FPLACE-13-0696

Re: FPL Turkey Point Units 6 & 7 Project, Application No. SAJ-2009-02417 (IP-MLC)

West Consensus Corridor

Reclaimed Water Treatment Facility (RWTF)

FIGURE 1.  
TRANSMISSION CORRIDOR GENERAL LOCATION

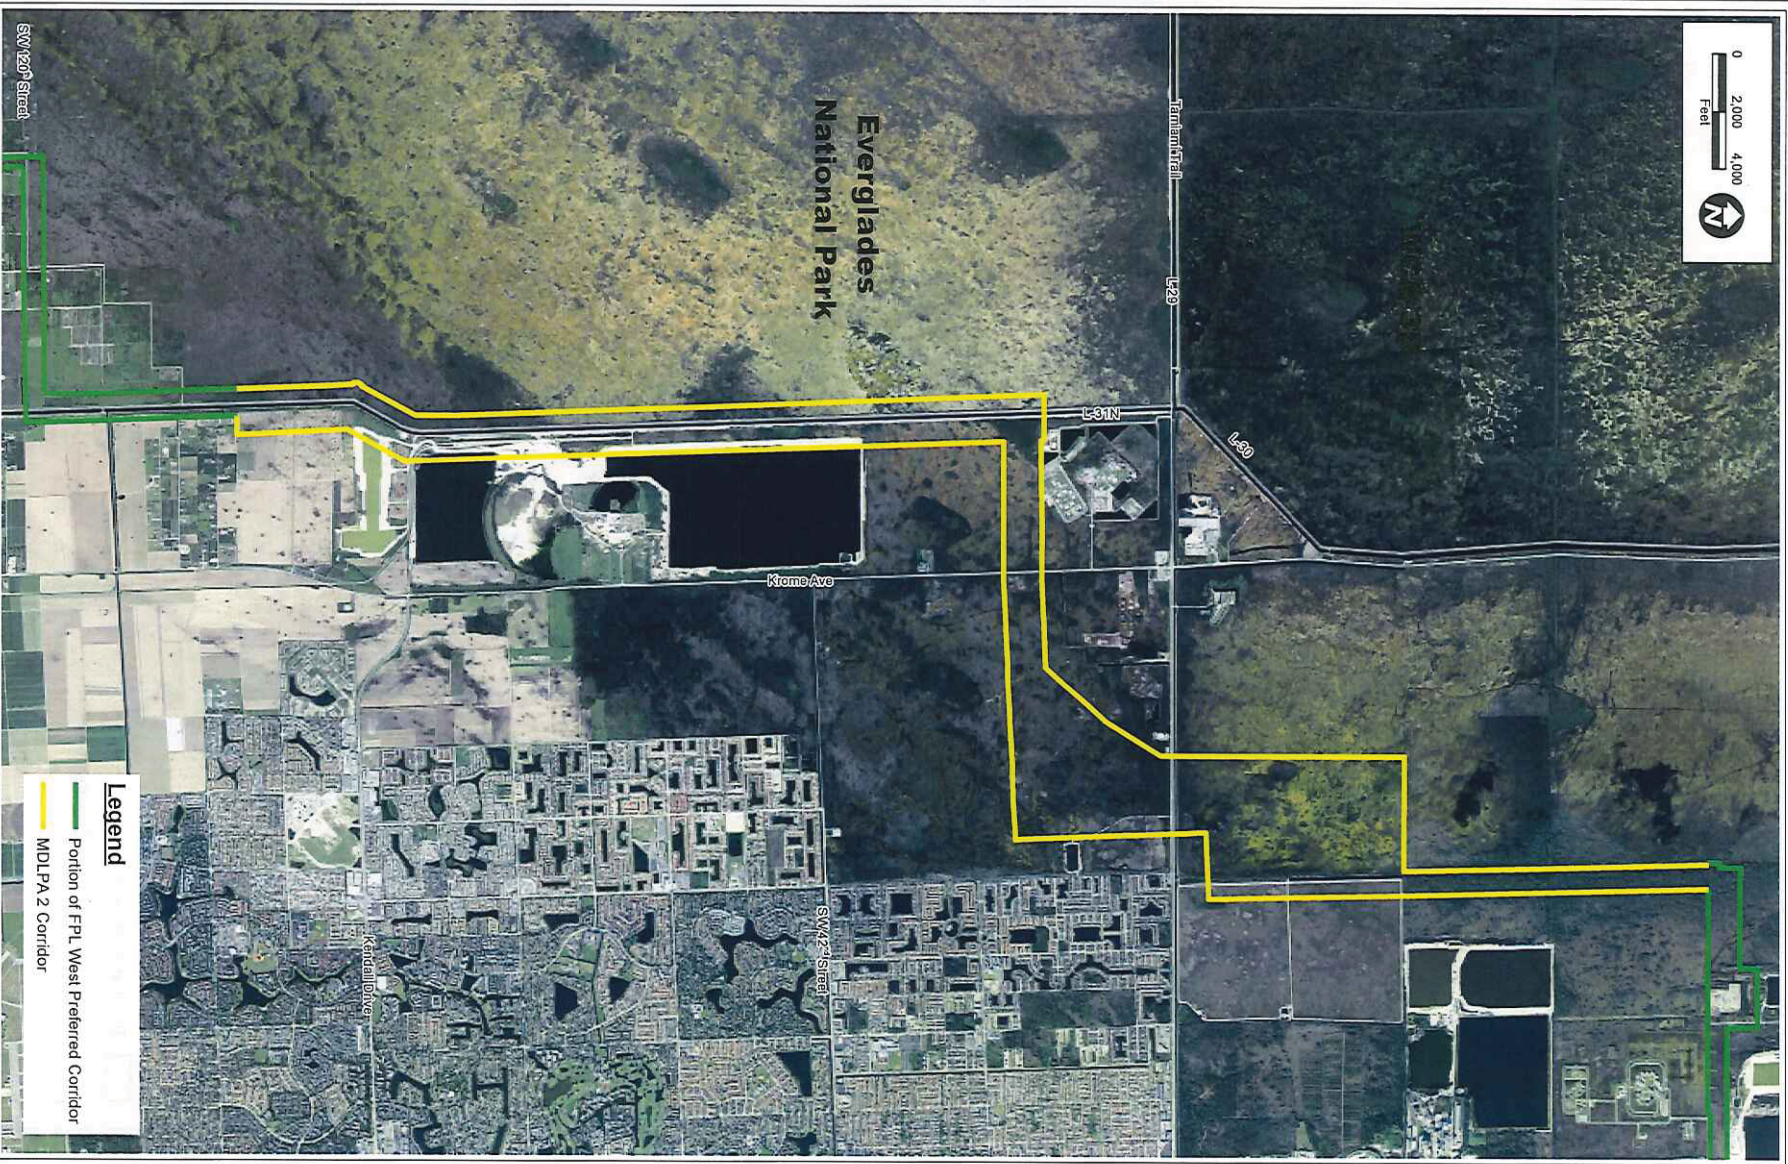
The selection of the West Consensus Corridor as FPL's preferred transmission corridor was introduced in FPL's September 11, 2013 response to the USACE June 4, 2013 request for additional information. In our continued effort to avoid and minimize environmental impacts, FPL has decided to obtain a permit for the "West Consensus Corridor", which includes portions of the southern and northern sections of FPL's West Preferred Corridor and the MDLPA 2 Corridor segment (Figure 1). Until the right-of-way can be acquired in the new corridor, free of encumbrances, covenants, or other restrictions in a cost-effective and timely manner, this option is not available and FPL will therefore continue to simultaneously pursue the permitting of the West Preferred Corridor as the backup location for the Project's western transmission lines. Based on the existence of two options for location of the western transmission lines, the West Secondary Corridor is no longer needed and thus FPL hereby withdraws the West Secondary Corridor from the Project's USACE Section 404 permit application.

On November 5, 2013, FPL submitted supplemental transmission corridor information (L-2013-311) to the Nuclear Regulatory Commission (NRC) which summarized the environmental and land use characteristics for the MDLPA 2 Corridor segment, consistent with the analysis of the West Preferred and West Secondary Corridors presented in the Combined License Application (COLA) Environmental Report (ER). FPL's September 11, 2013 response to the USACE's request for additional information (RAI) included analysis of the MDLPA 2 corridor segment, including the approximate wetland impacts based upon conceptual structure pad dimensions, span lengths, and access road designs.

As discussed in the submittals identified above, construction of the proposed transmission facilities within the West Consensus Corridor would reduce potential adverse impact to wetlands and threatened and endangered species when compared to the West Preferred Corridor through increased utilization of previously disturbed habitats. The West Consensus Corridor contains a greater acreage of disturbed, low quality wetland habitat dominated by exotic vegetation and is located further east from existing wood stork colonies when compared to the West Preferred Corridor. Based on conceptual designs, construction of transmission facilities within the West Consensus Corridor reduces wetland impacts by approximately 14 acres and wetland functional loss by 21 UMAM units compared to the West Preferred Corridor.
